Subject: Martin Temporary Rule Curve

RE: Martin Project, FERC No. 349 and Yates and Thurlow Project, FERC No. 2407

Alabama Power is requesting FERC approval for a drought-based temporary variance to the Martin Project rule curve, which is described as follows;

Attachment 1

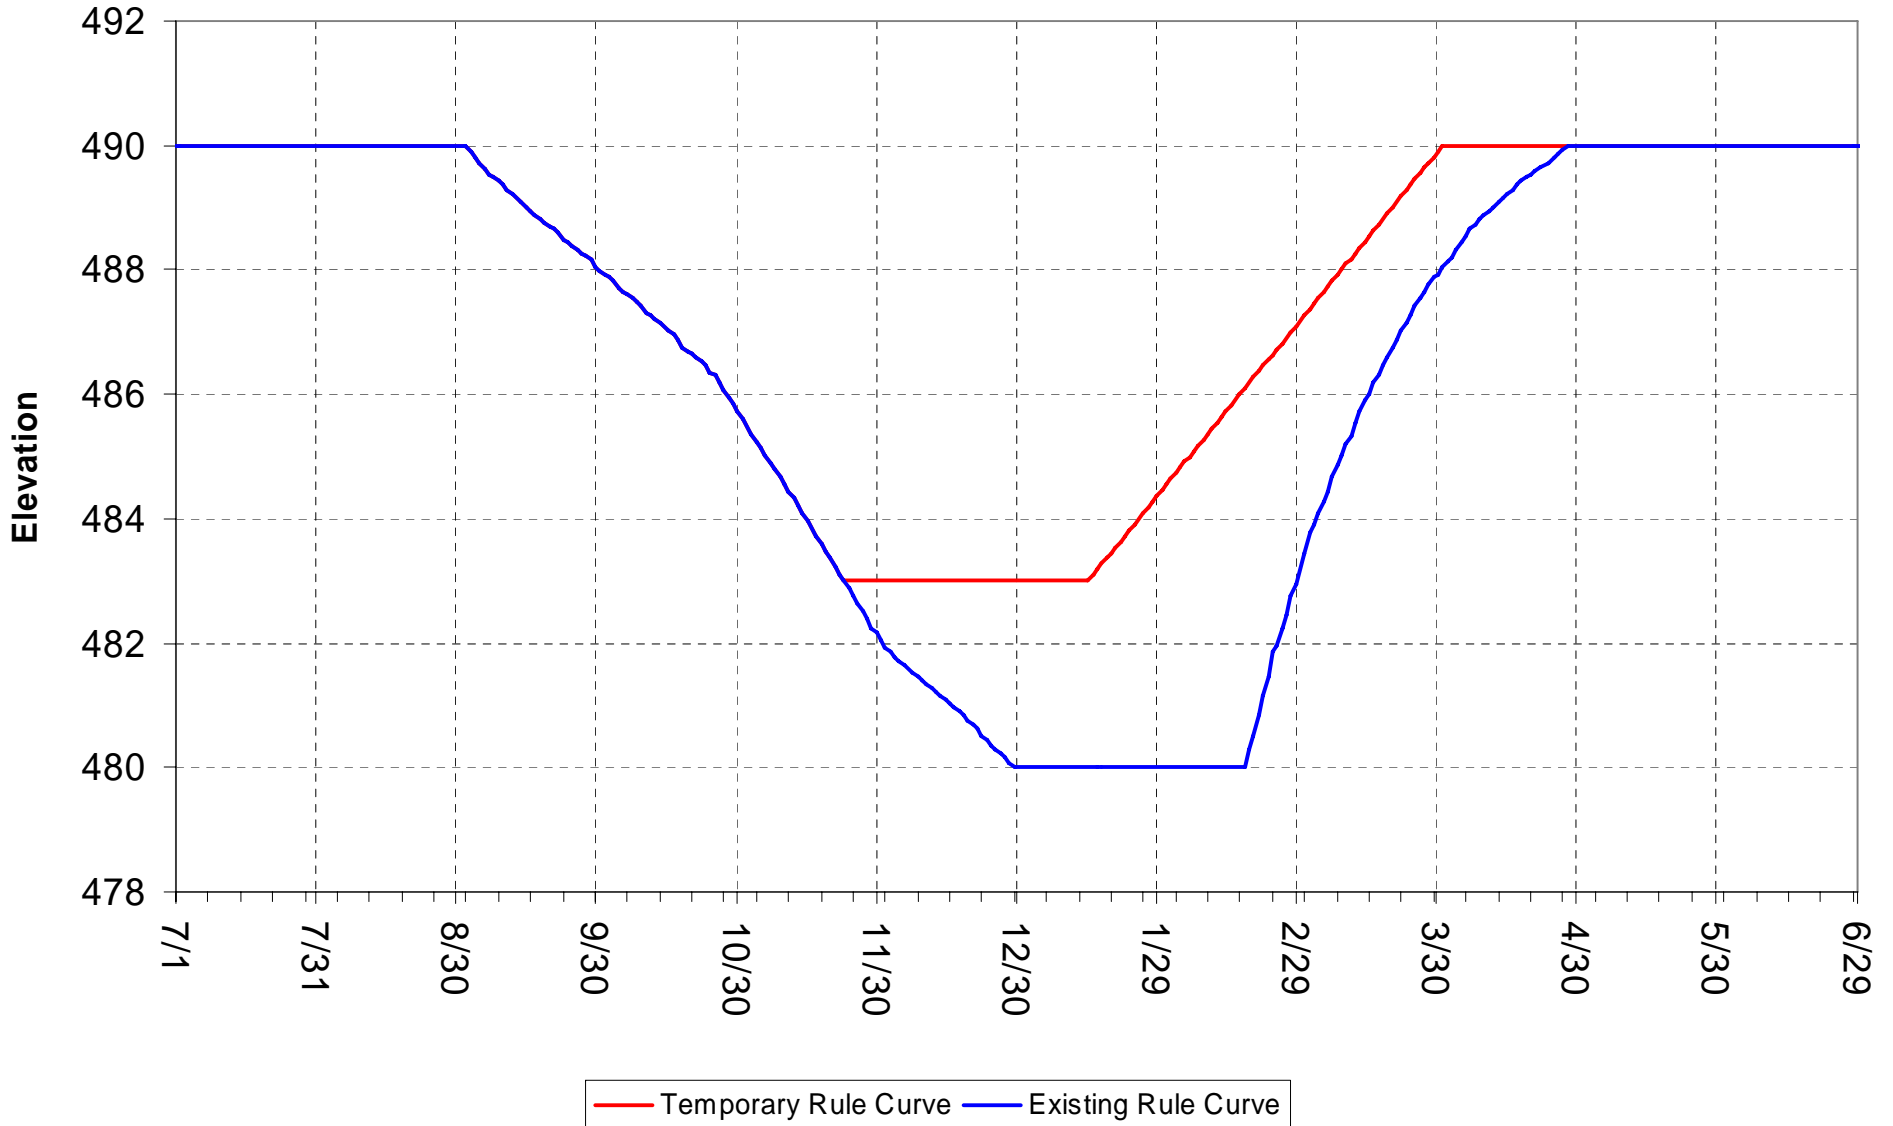
1. Maintain the winter pool elevation 3 feet higher than normal, at El. 483 instead of El. 480.
2. Begin maintaining the winter pool elevation earlier than normal, on November 20th rather than January 1st.
3. Initiate the filling process earlier than normal, beginning January 15th instead of February 15th.
4. Reach and maintain summer pool elevation earlier than normal, on April 1st rather than May 1st.

Martin Project -
Without Proposed Drought-Based Temporary Variance

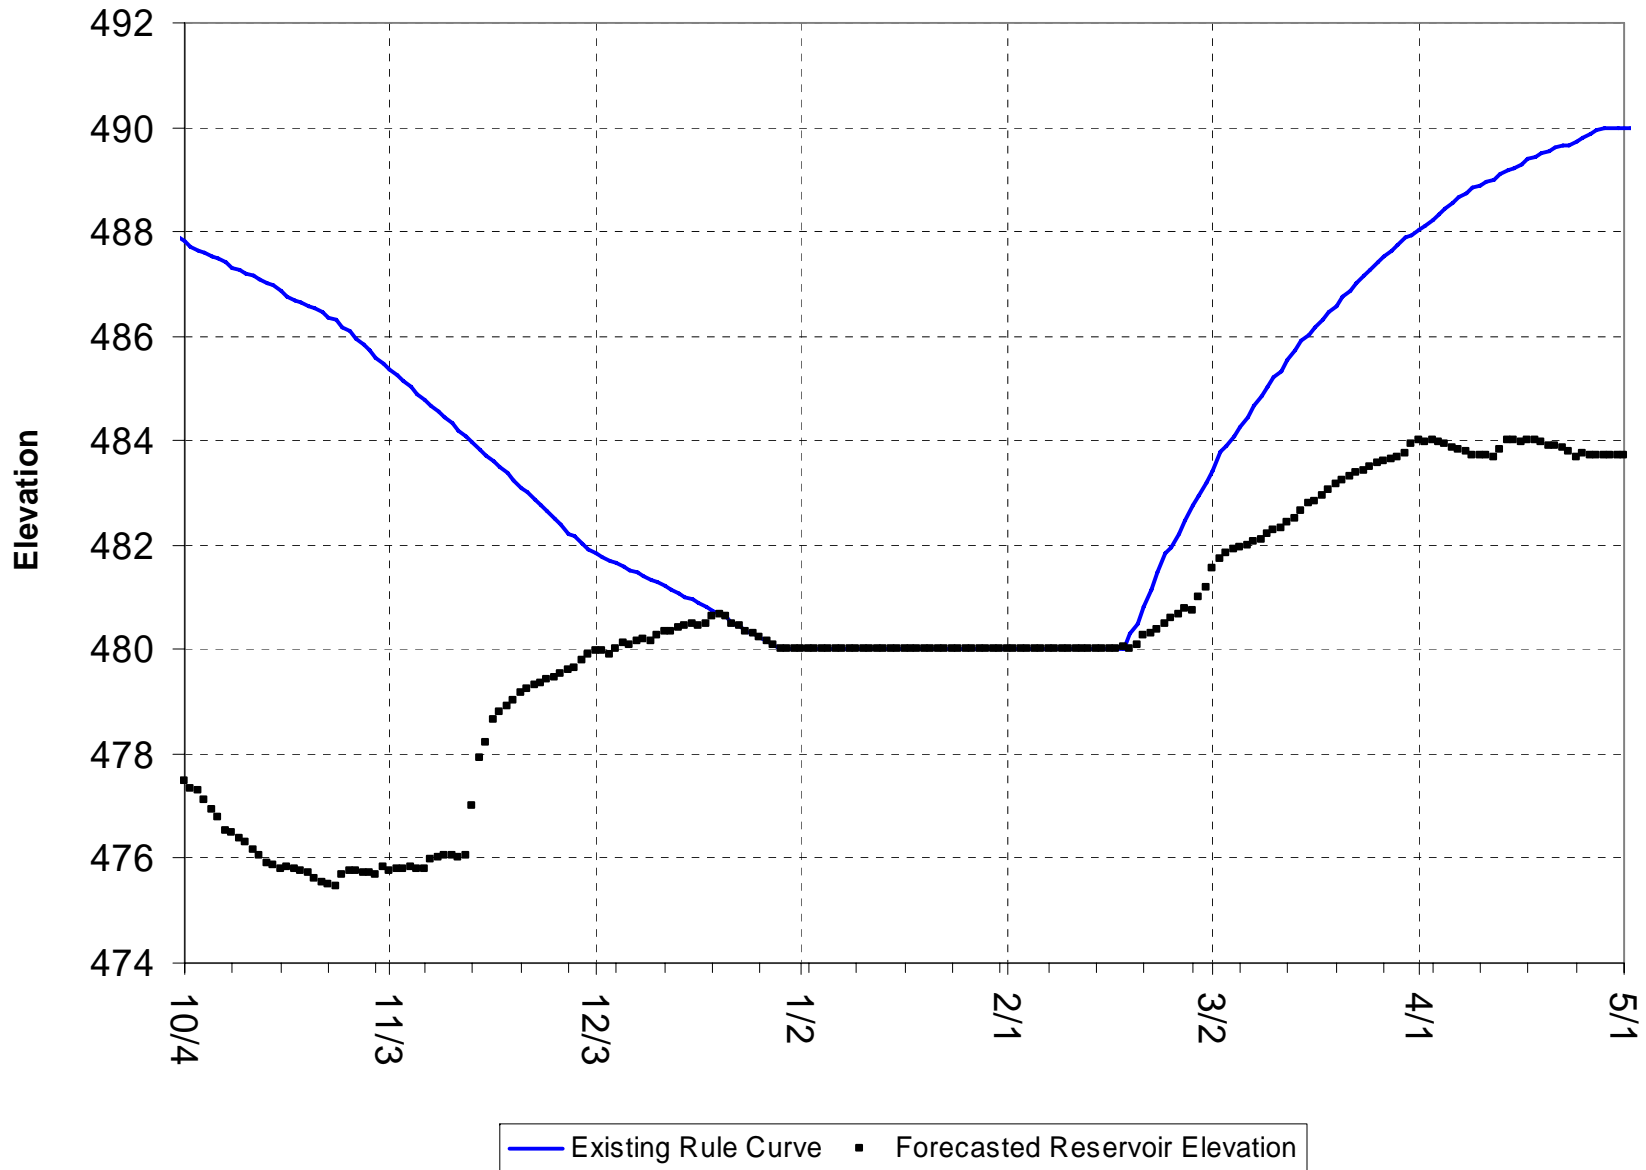
This variance request is shown graphically on the enclosed Attachment 1. Also enclosed are graphs depicting the projected Martin Reservoir elevations from modeling runs made without the rule curve variance (Attachment 2) and with the variance (Attachment 3). The projections depicted in these attachments are based on actual inflows from 2006 and 2007, with two significant rain events dampened to reflect the unfavorable rainfall forecasts and a continuation of the severe drought conditions. As Attachment 2 clearly shows, in the absence of the variance, Martin Reservoir is expected only to reach El. 484, which is six feet below the normal summer pool elevation. As seen on Attachment 3, with the rule curve variance in place, there is a good possibility that Martin Reservoir could reach summer pool by early April, which would greatly enhance Alabama Power's ability to support the many reservoir and downstream needs during next summer's critical period.

Example - Thurlow Minimum Discharges

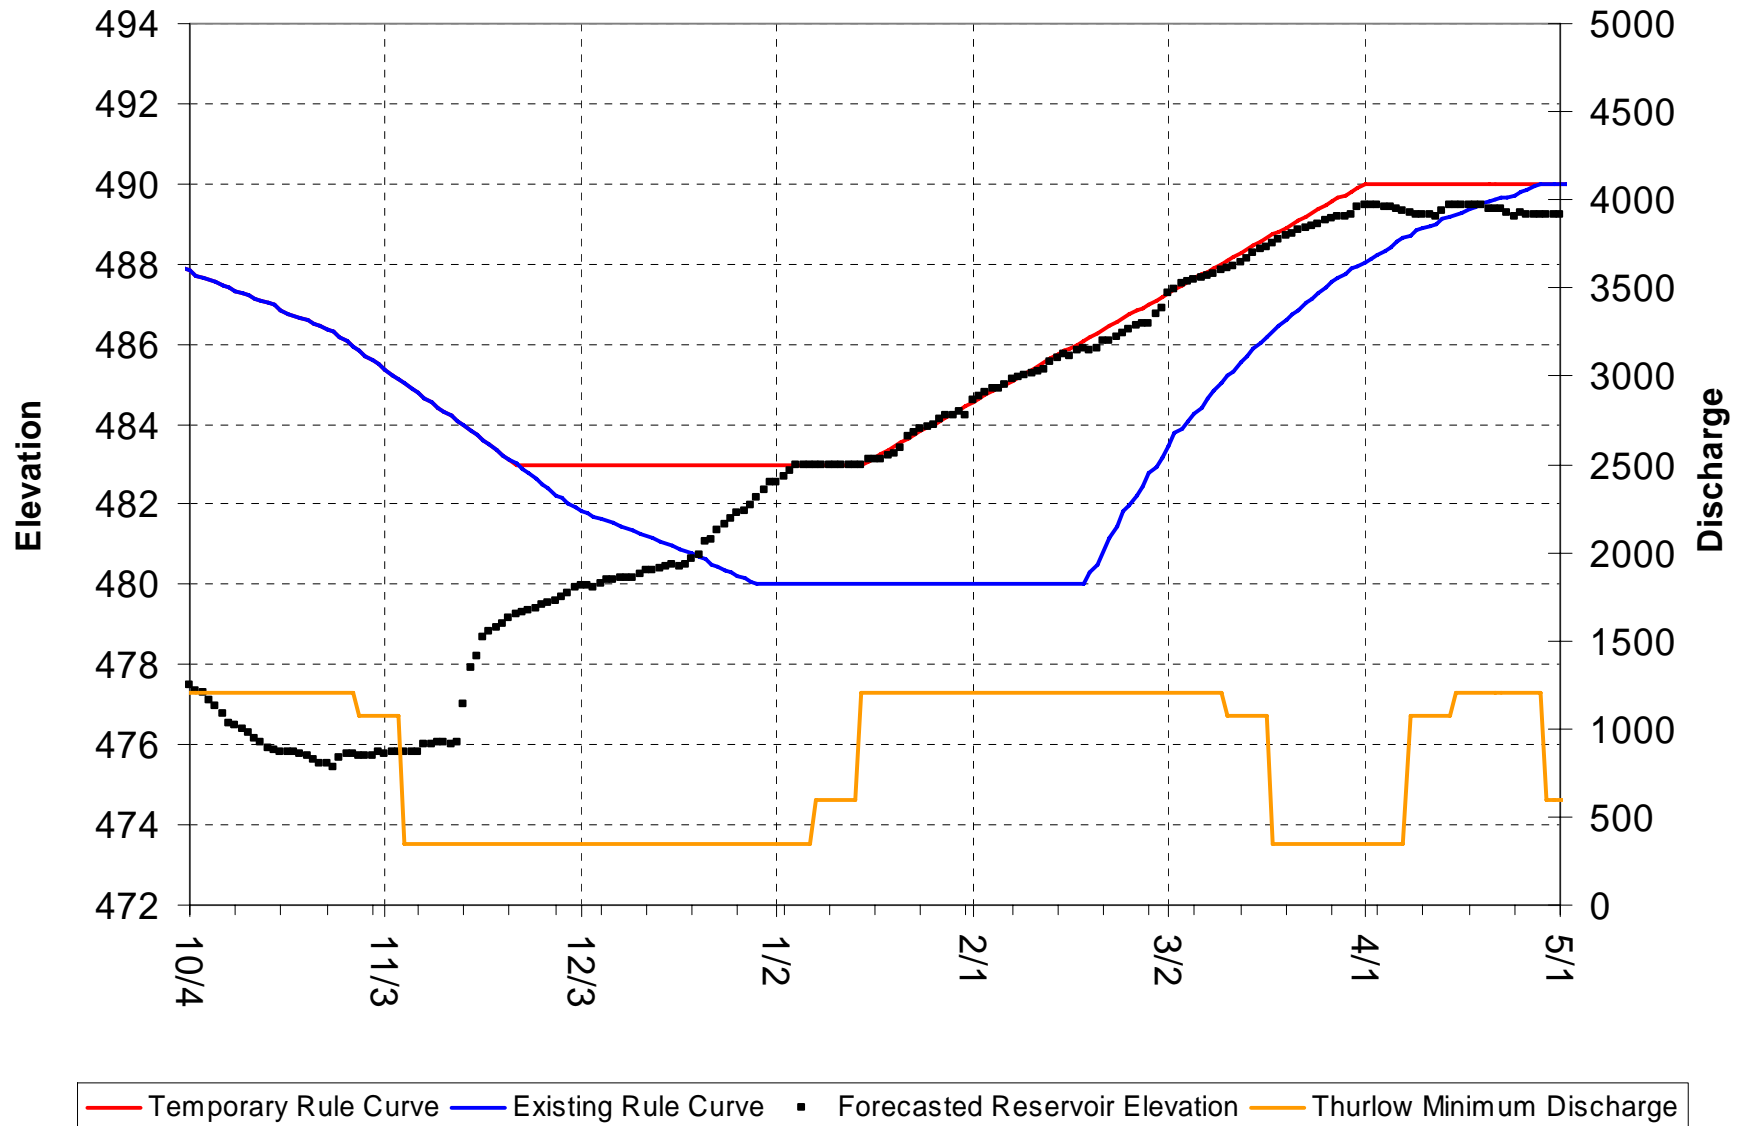
1. Change will be in effect until May 1, 2008.
2. Discharge no less than 350 cfs until the Martin Reservoir elevation reaches the existing rule curve.
3. When the reservoir elevation is at or above the existing rule curve but below the temporary rule curve, Alabama Power will discharge the greater of 350 cfs or the inflow at the upstream Heflin gage.
4. When Martin Reservoir elevation is at or above the temporary rule curve, Alabama Power will discharge no less than 1200 cfs from Thurlow.

This Thurlow flow release modification is shown graphically on the enclosed Attachment 4.
